Pasture Field Lane – Parish Council concerns – updates.

1.

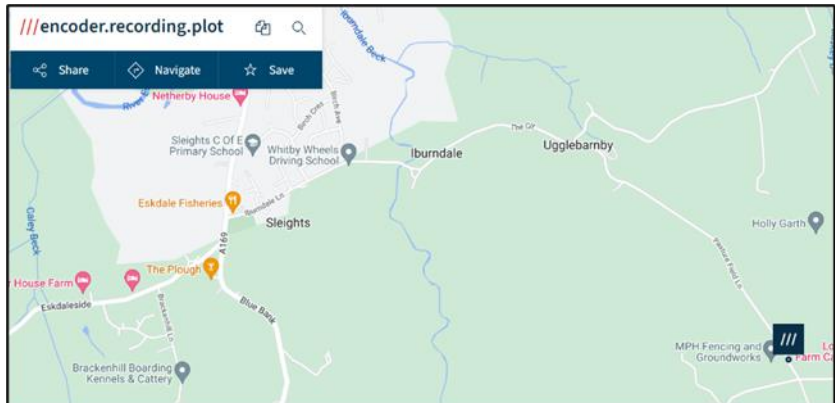
The What3Words street view image does not look like this photograph, so I am not sure if the location is correct. I have shown the defect to our Senior Engineer, and they commented that the defect is off the highway – this passing place or pull in is unofficial and its use has caused the defect which will be monitored during the routine safety inspections.

3.

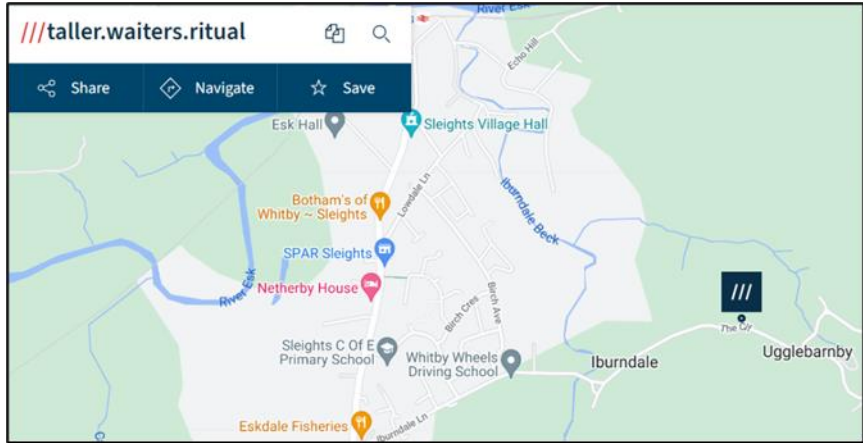
Verge over running damage – not at intervention levels unless there is a difference of 20cm we would not take any action and then all we could do was to pull the verge back to the edge of the carriageway.

4.

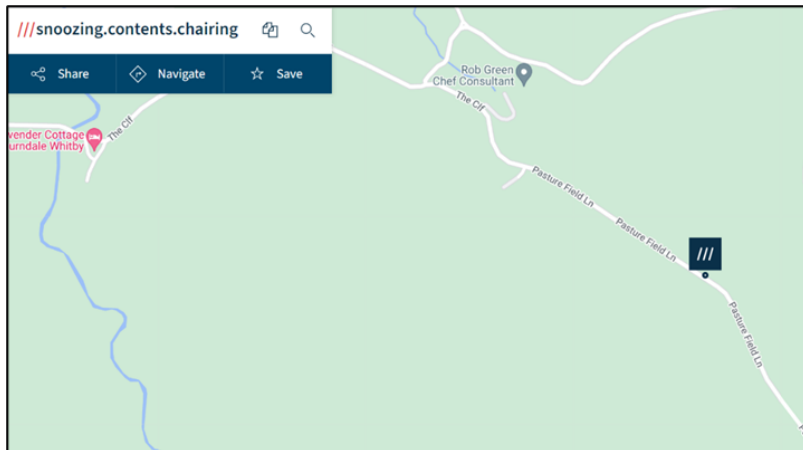
We are not quite sure what the defect is here that the PC are reporting. If it is a possible water leak, then could you please report this to Yorkshire Water.

5.

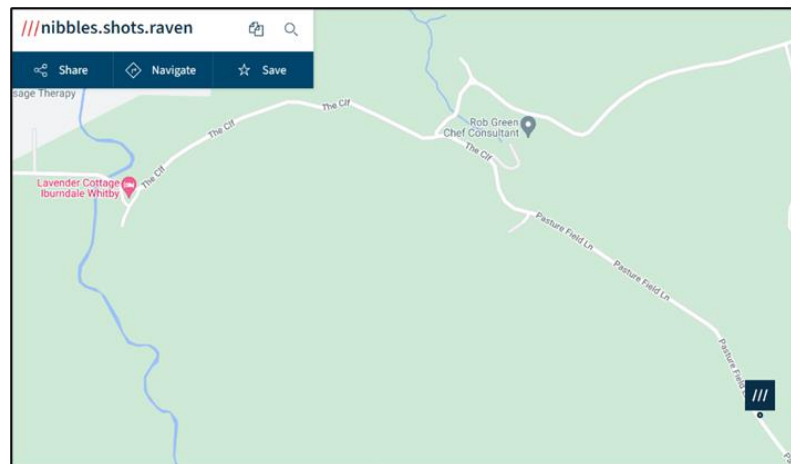
Have raised this as a case for the local highways officer to inspect.

6.

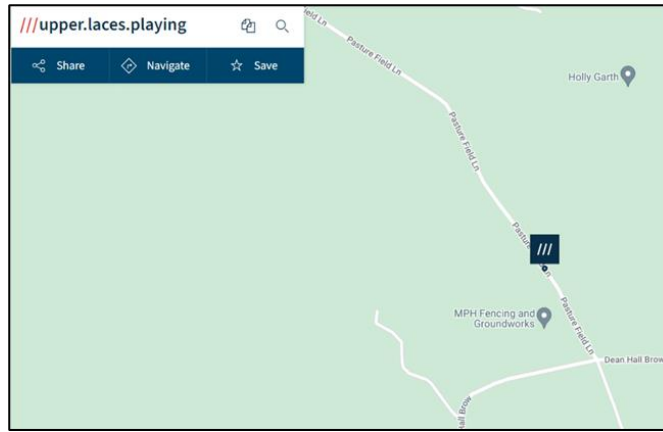
Have raised this as a case for the local highways officer to inspect.

7.

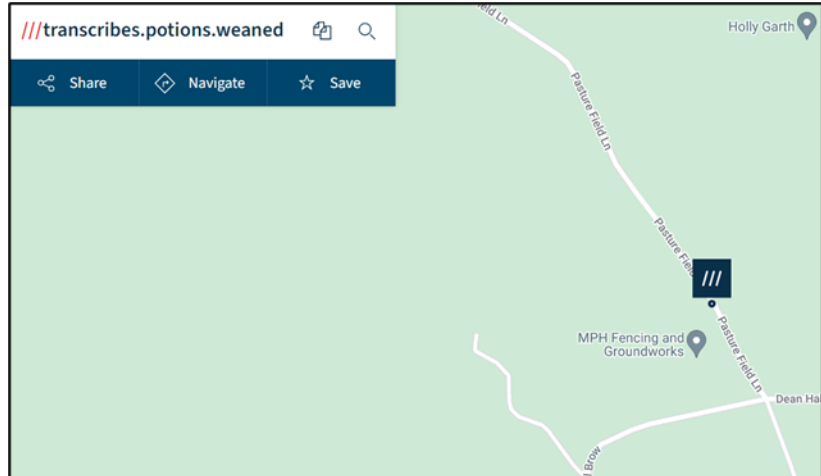
We suspect that this is again edge damage caused by vehicles over running the highway verge. We have asked the local highways officer to inspect the defect. There also seems to be quite a lot of water coming out of the field in the top left of the picture – the landowner would need to take action here to prevent water from their land getting onto the highway.

8.

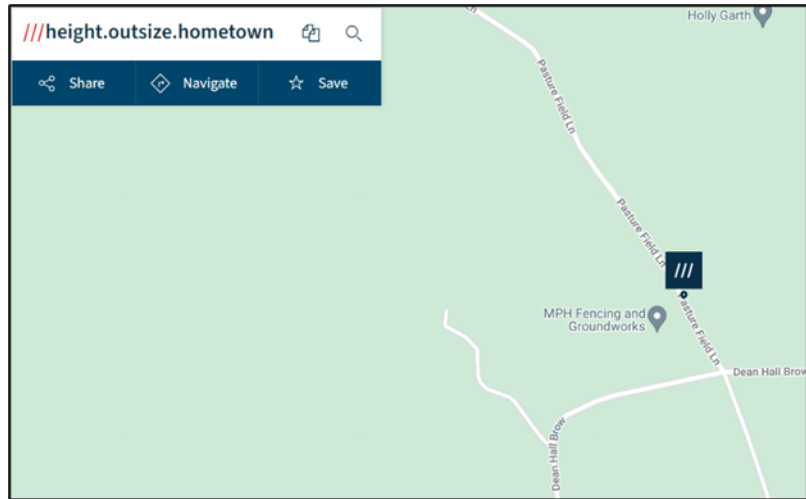
Passed to the local highways officer to inspect.

9.

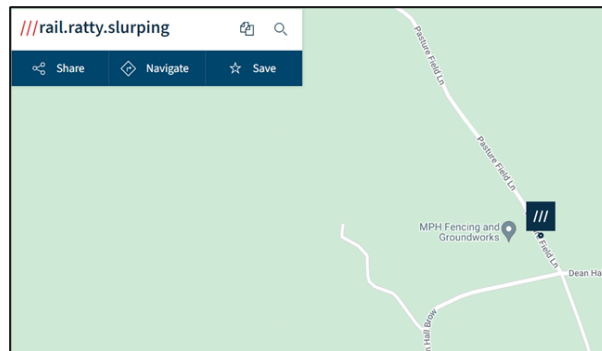
The image shows water running down the highway verge – if this is coming from the land this needs to be addressed by the landowner.

11.

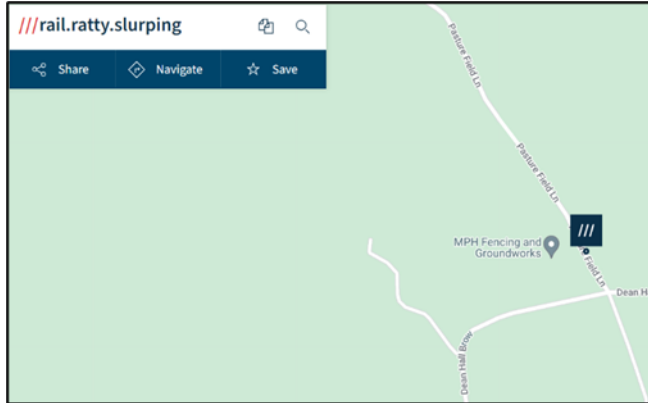
Same location as 9 & 10 above – again damage caused by poor driving – case raised for the highway officer to inspect and arrange the necessary repairs.
